HAMILTON WATCH CO., INC.

License No. 37-03572-06  
Docket No. 030-12704  
Control No. 103666

The following memo contains responses to your questions sent to me in your letter of June 24, 1985. All responses are in reference to amend License No. 37-03572-06 which was dated April 10, 1985.

Room Lay-out for Gaseous Tritium

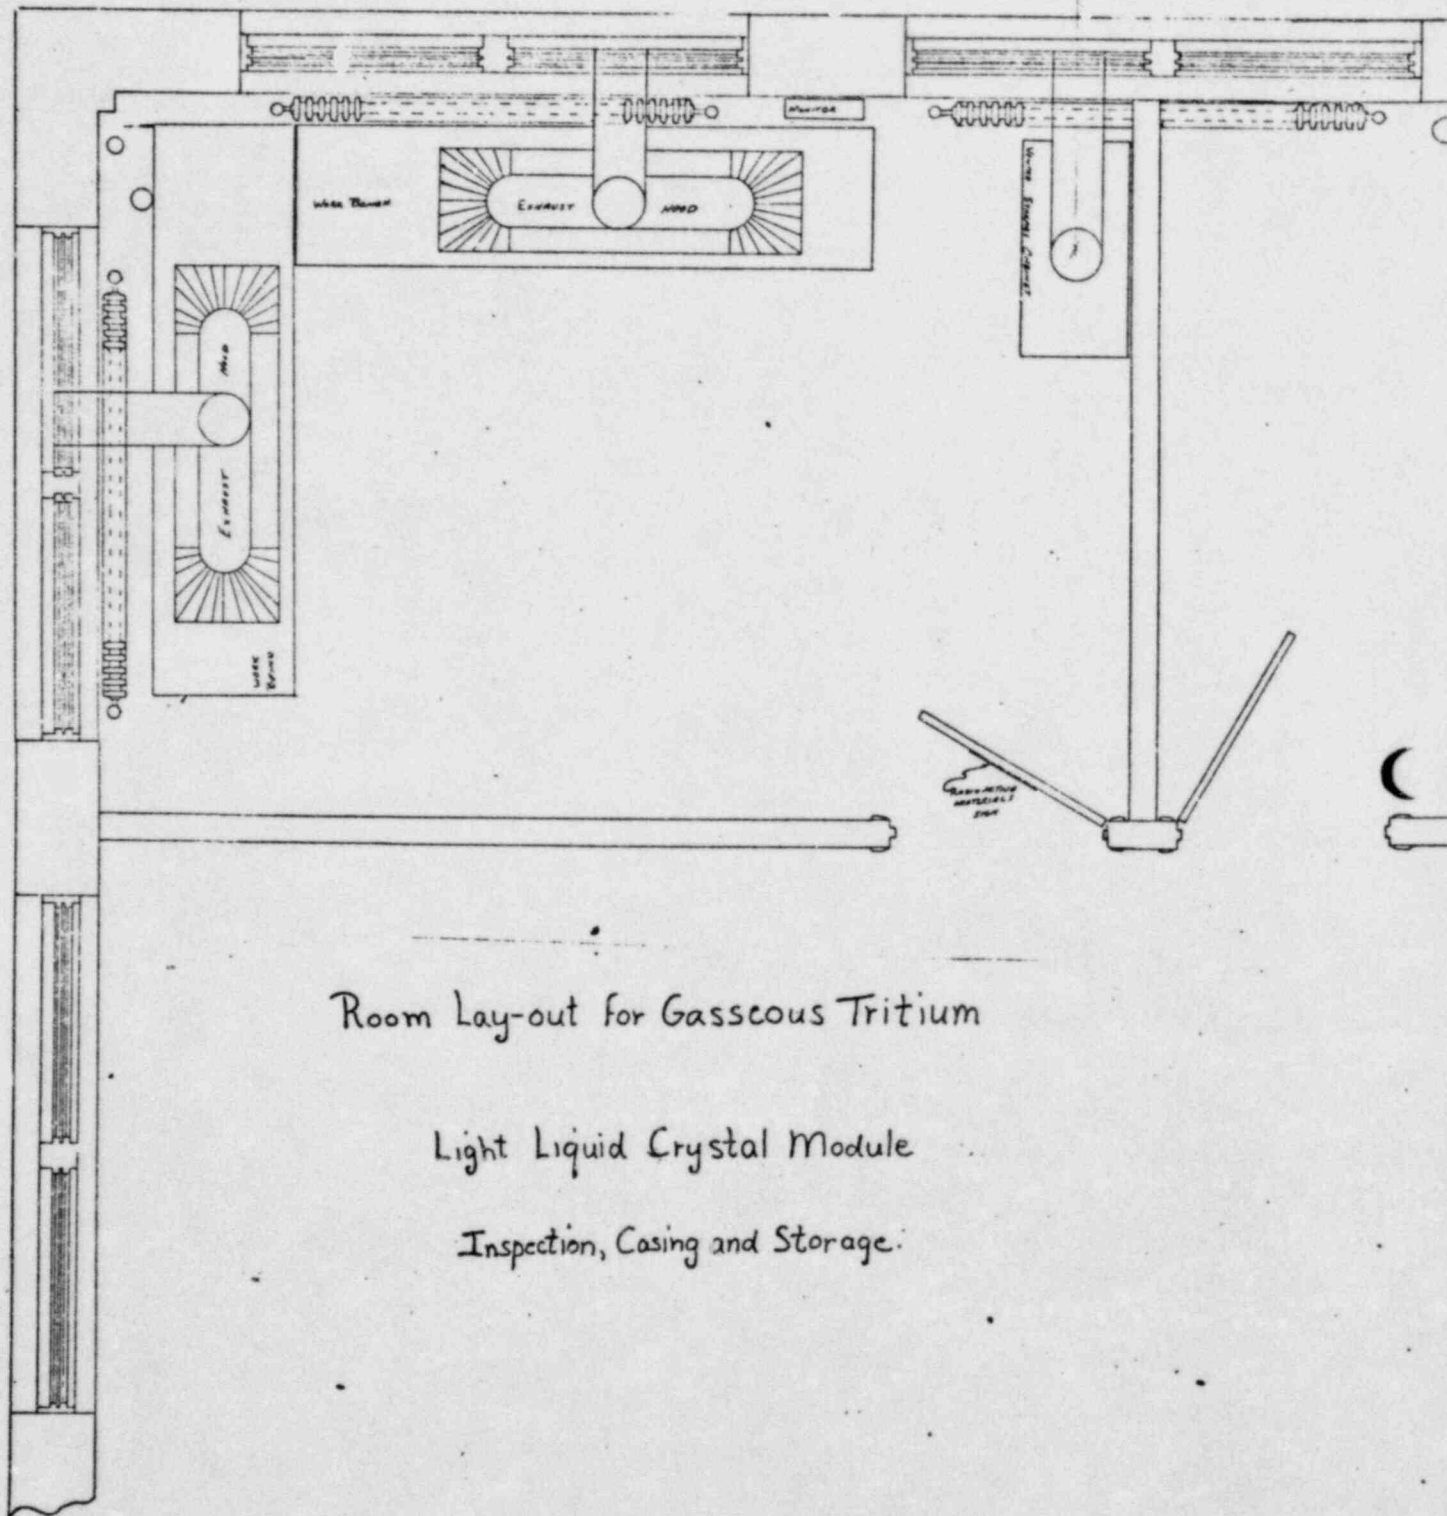
Item 3 - Facility Description

I have enclosed a copy of our tritium room layout for your review.

This area is secured during off working hours for no one's admittance. The following signs are posted on the entrance door:

Modules are repaired under exhaust hoods which have an air flow of 200 cubic feet per inch. Discharge is to the atmosphere with no return permitted. We store the modules in a cabinet which has an exhaust air flow of 200 cubic feet per inch. The discharge is to the atmosphere with no return permitted.
